CITY PLAN COMMISSION STAFF REPORT

CD-CPC-2026-00017

Plaza Apartments Garage Replacement

April 15, 2026

OVERALL SITE PLAN

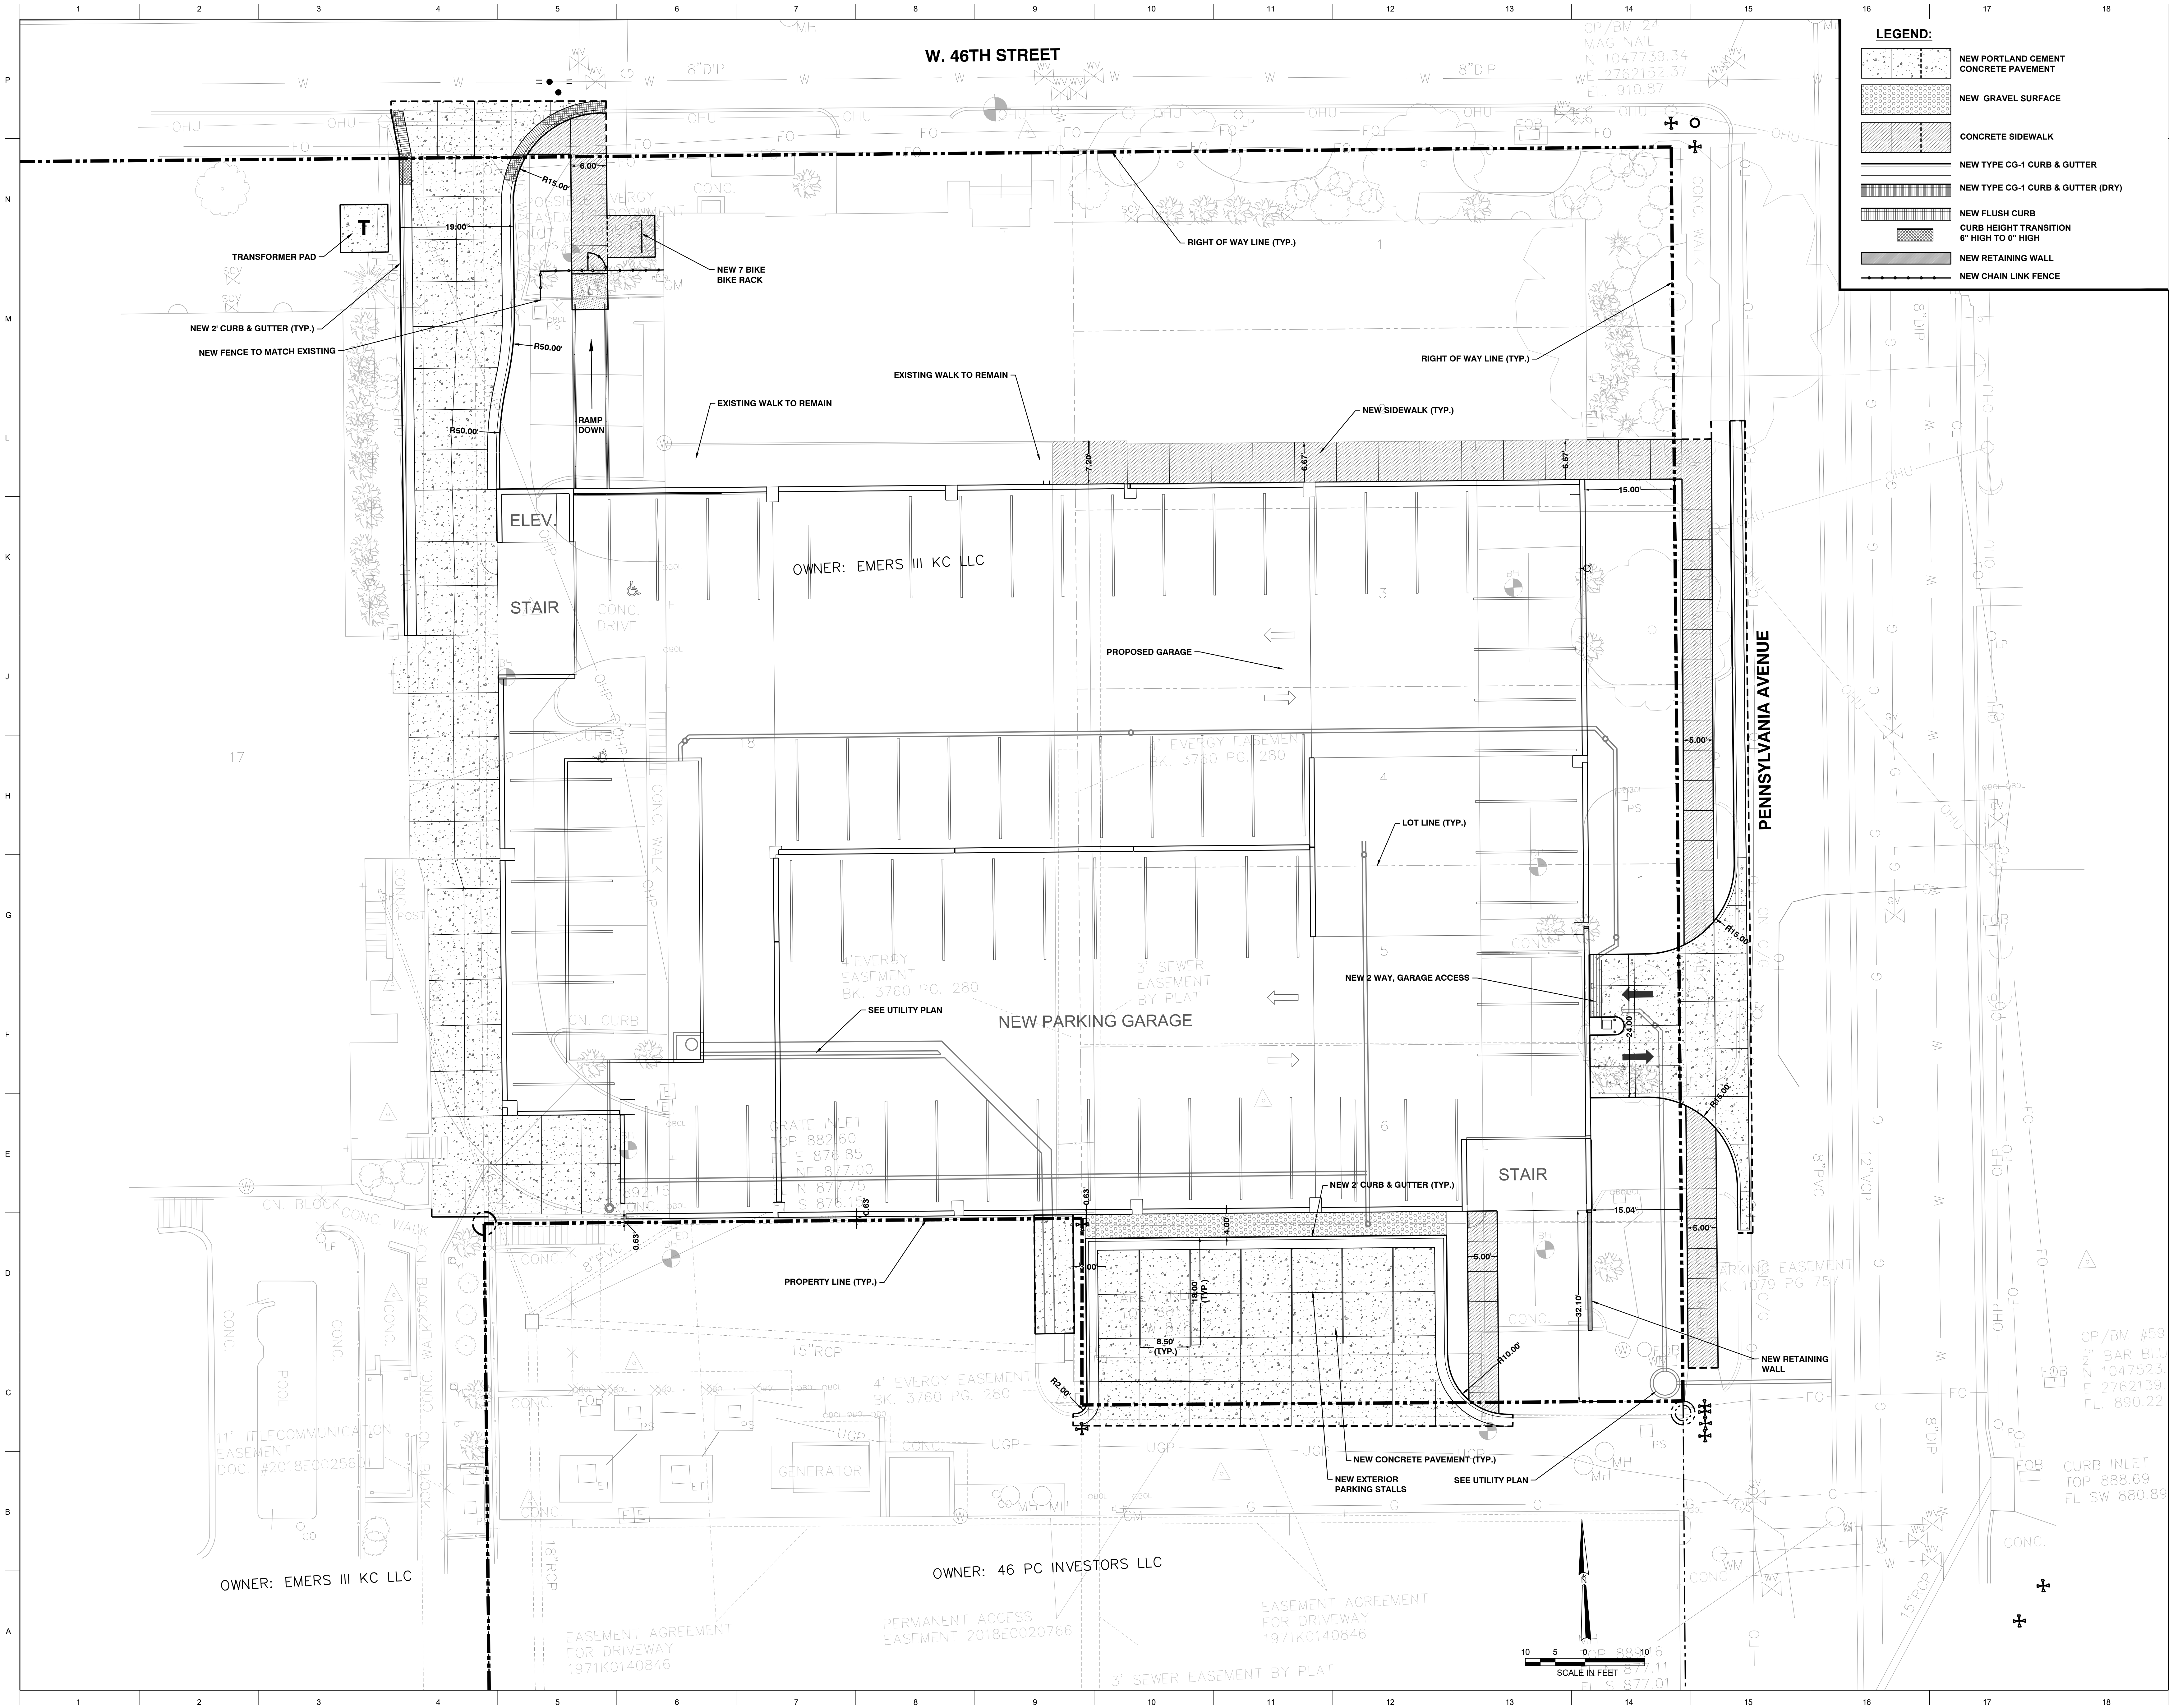
The Applicant has agreed to a striped crosswalk across the access onto Pennsylvania. Planning is proposing a few elements be added to this access drive for pedestrian safety.”- Susan Cronander, 6th District Community Planner

The Applicant has agreed to a striped crosswalk across the access onto Pennsylvania. Planning is proposing a few elements be added to this access drive for pedestrian safety.

3. Please consider additional pedestrian safety promoting elements at the access drive where it intersects with the sidewalk such as providing speed cushions or landscaping/trees/planters/decorative elements of some sort at the entrance indicating to drivers that they may encounter pedestrians (thank you for providing striping).

LANDSCAPE PLAN
L101
FINAL DEVELOPMENT PLAN

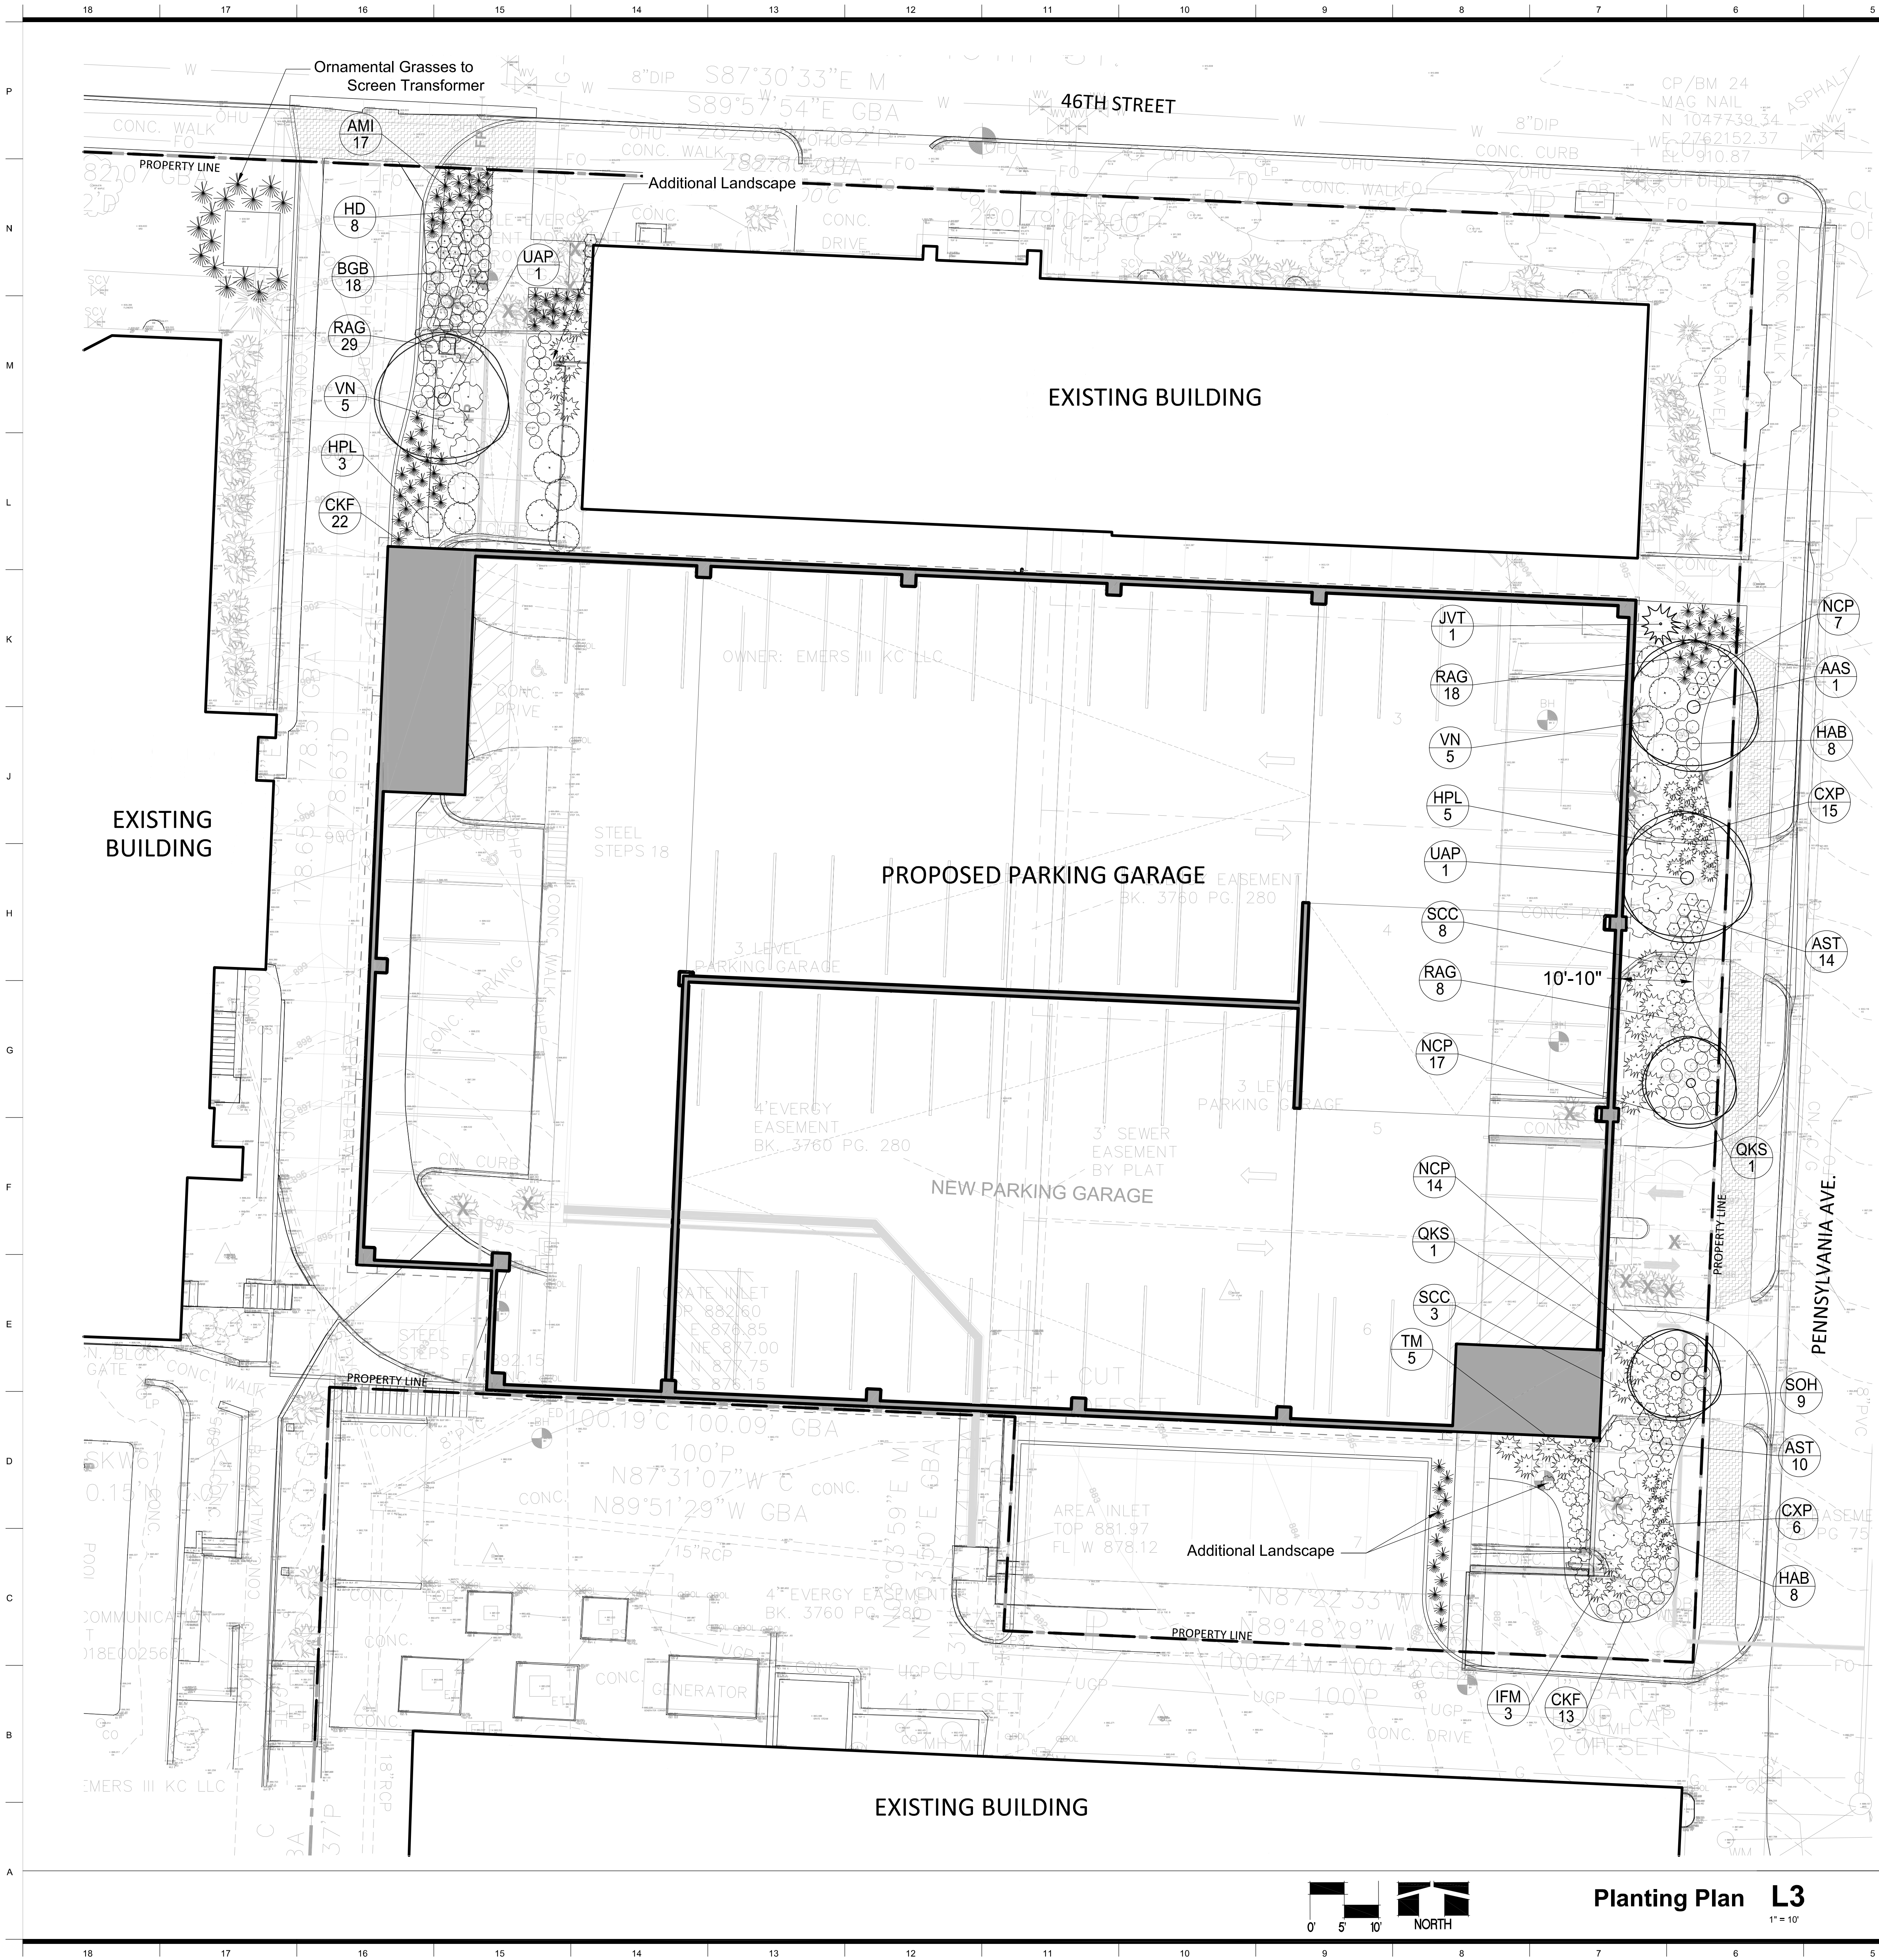
This proposal also has a lush landscaping plan facing Jefferson Street. Community Planning asks that some pet protection for the landscaping be provided so that it has a chance to mature.

This proposal also has a lush landscaping plan facing Jefferson Street. Community Planning asks that some pet protection for the landscaping be provided so that it has a chance to mature.

4. Provide some pet protection for the proposed beautiful landscaping.
